# COUNTAX™

## SERVICE BULLETIN

09-T4-58

MODELS CONCERNED: A2050 & A2550 42" HGM Deck

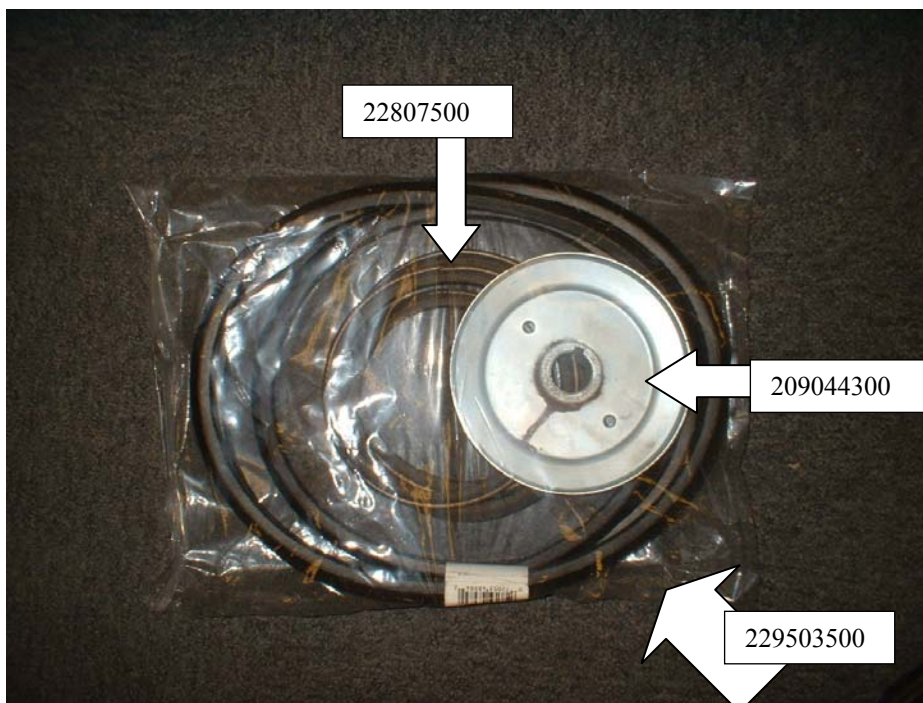
CONCERN: Deck cover is being worn away

Heat generated from the belt is melting the deck cover due to the speed the pulley configuration is running at. If a bigger pulley is used this should slow down the speed of the pulley configuration and cause less heat to build up.

Currently the deck is using a 120mm DIA driving pulley (20869600) and a B52 belt (229503200). This needs to be changed to use a 150mm DIA pulley (209044300) and a B54 ½" Belt (22807500).

The Internal belt (BB100 229503500) and the deck cover (148002402) remains the same.
